RE: Stafford – CPA 1-19; ZC 1-19; PDA 2-19; PD 1-19; s 1-19; L 2-19

I have the following comments about Stafford's Charbonneau-produced traffic study:

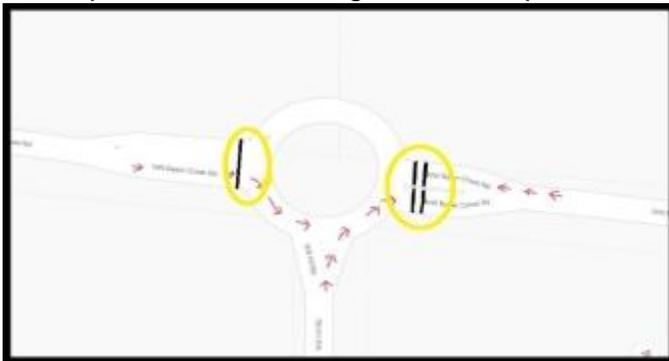
5. **Move the Location of the Proposed Baker Creek North Commercial Zone East to the Area Near the Electric Substation and Put a Light at Meadows.** That puts the commercial area across the street from Meadows, which is next to the BPA trail. Since the trail is to be continued through Baker Creek North, the enhanced intersection will provide a safer pedestrian crossing site for people wanting to use the entire trail. It will provide a safer intersection for foot traffic to access whatever commercial tenants might be found for Baker Creek North.
